Serial No.: 09/902,023

For: Method for Constructing A
Multistory Building

THIRD PROPOSED DRAWING AMENDMENT

Date: December 23, 2004

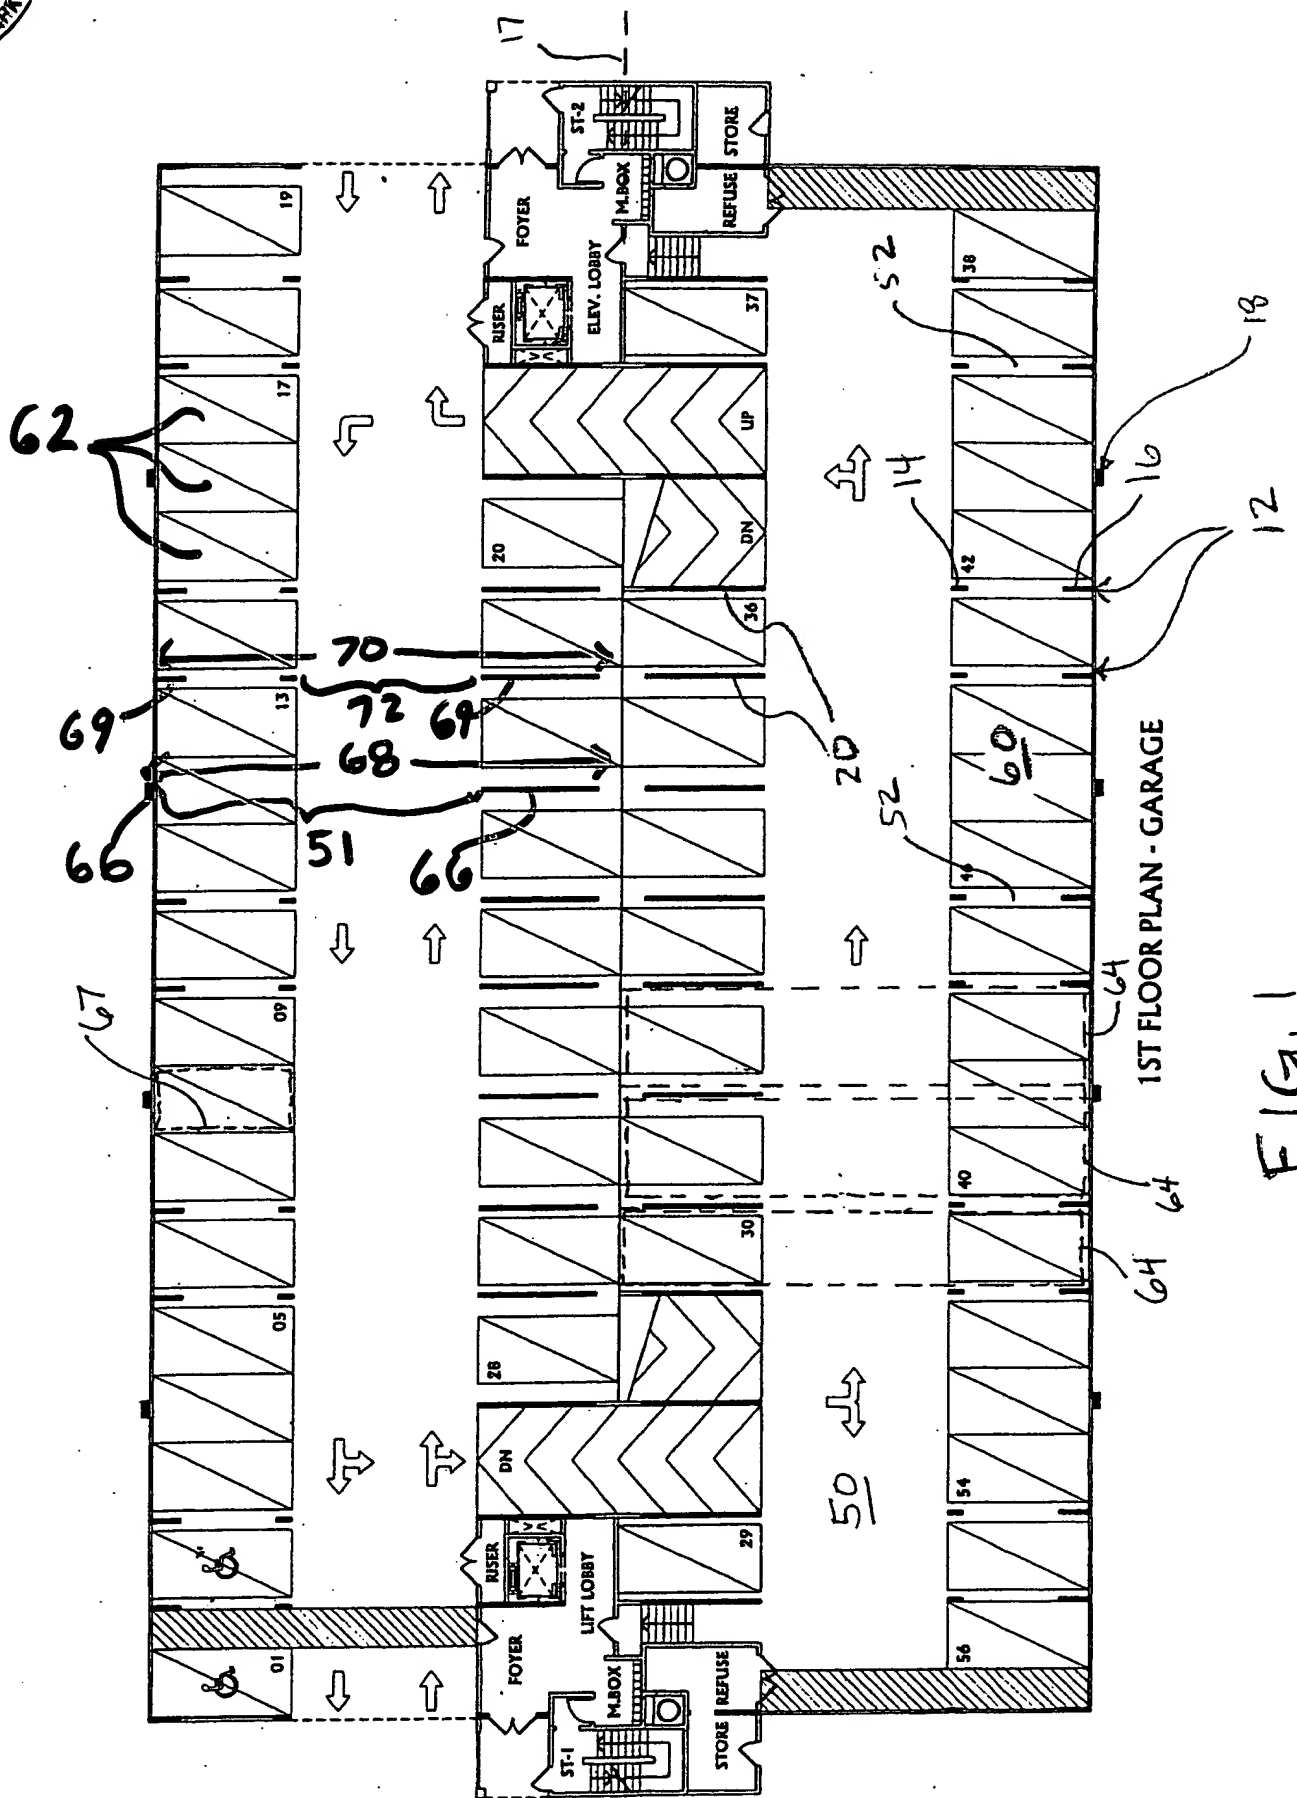
The Examiner objected to the drawings on the grounds Figure 1 does not illustrate reference numeral 62 and that certain other reference numerals are not shown on Figure 1. A third Proposed Drawing Amendment is submitted herewith, in which the reference numerals in question have been added to Figure 1. The Proposed Drawing Amendment also includes an amendment correcting an error in Figure 5.

In response to the Office Action dated October 25, 2004, Applicants submit the attached sheet containing proposed amendments to Figures 1 and 5. Specifically, several reference numerals have been added to Figure 1 and a correction has been made to Figure 5.
